# **DOWNTOWN ANTIOCH**

## **Draft Form-Based Code**

### **Draft for Village of Antioch Review Only**

June 7, 2010

Figure 3.7: Typical Parking Placement in VC District

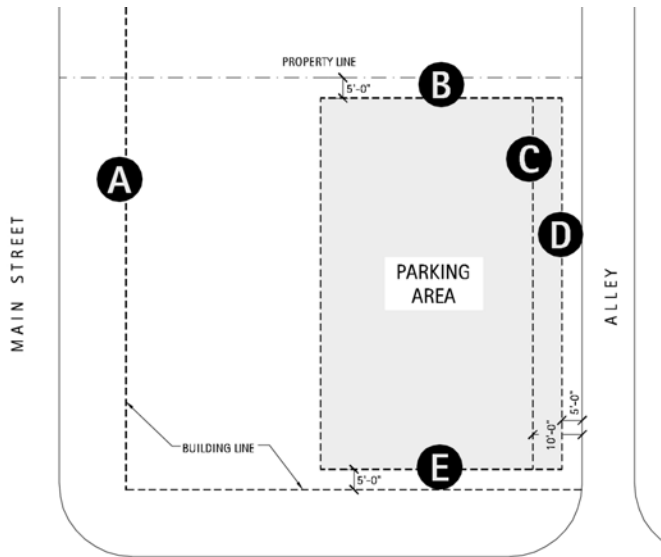
Off-street parking not contained within the building is encouraged [DN Comment: Should it be required?] to be placed in the rear of the building or underground to reduce the visibility and impact on safety of the pedestrian environment. As shown in **Figure 3.7**, surface parking must be placed as follows:

- E. 5 feet from the Building Line on the side yard of a corner lot. [Tree? Width]

Figure 3.12: Typical Parking Placement in TC District

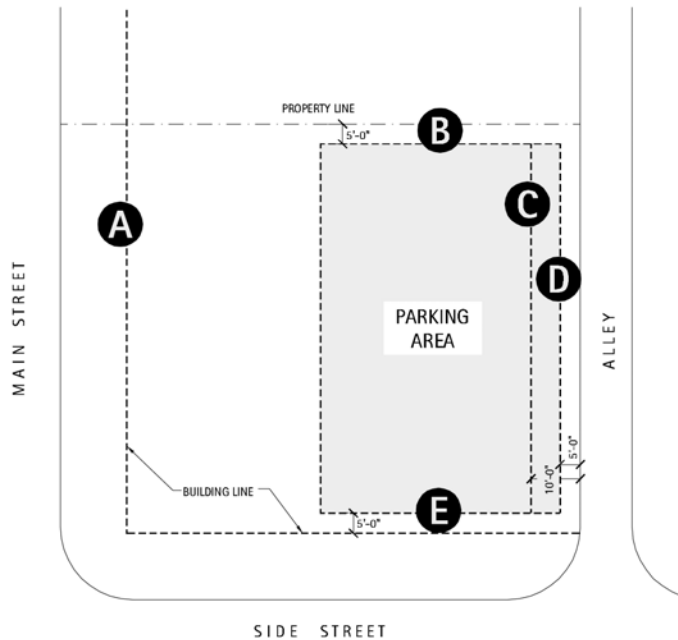
- A. Placed in the rear 50% of the lot depth (from the front Building Line to the rear property line).
- B. 5 feet from the side yard (adjacent commercial parking lots must be connected at grade).
- C. 10 feet minimum from the rear of the lot if not adjacent to an alley.
- D. 5 feet minimum from the rear of the lot if adjacent to an alley.
- E. 5 feet from the Building Line on corner side yards.  
[DN Comment: Landscape Quantities]

Figure 3.13: Schematic internal access structure – Superblock Site

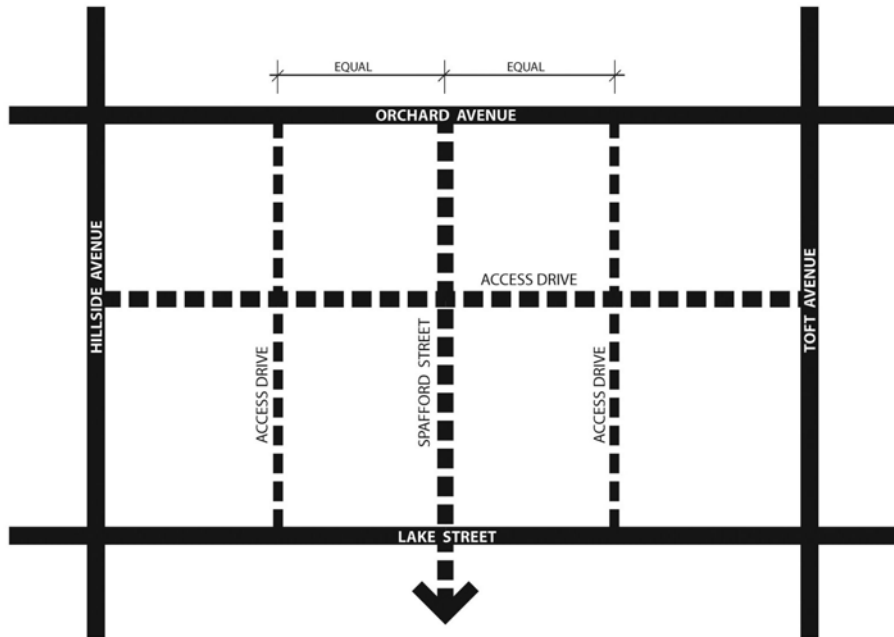
[DN Comment: Add cross-sections for Access Drives and Spafford Street extended]

Figure 3.18: BP District Parking Placement

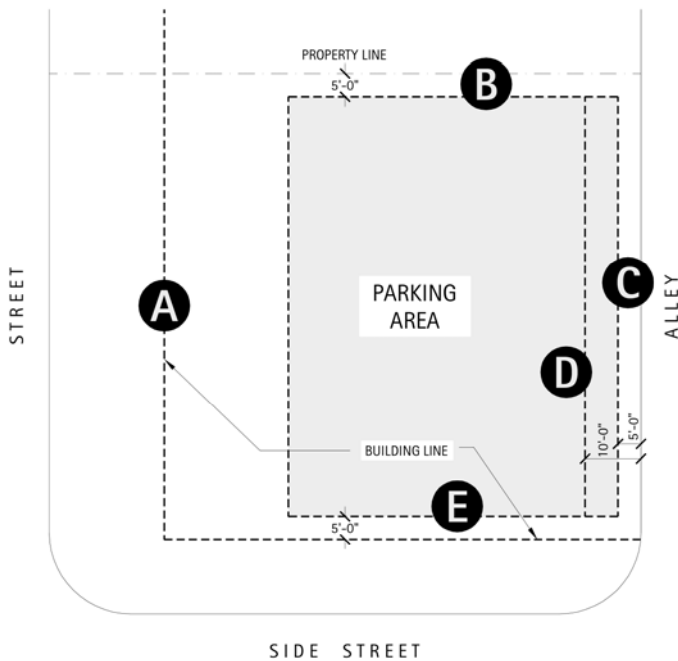
- C. 5 feet from the rear if adjacent to a rear alley. [DN: N/A]
- D. 10 feet minimum from the rear of the lot.
- E. 5 feet from the Building Line on the side yard of a corner lot.

[DN Comment: Residential and Vs. Storage]
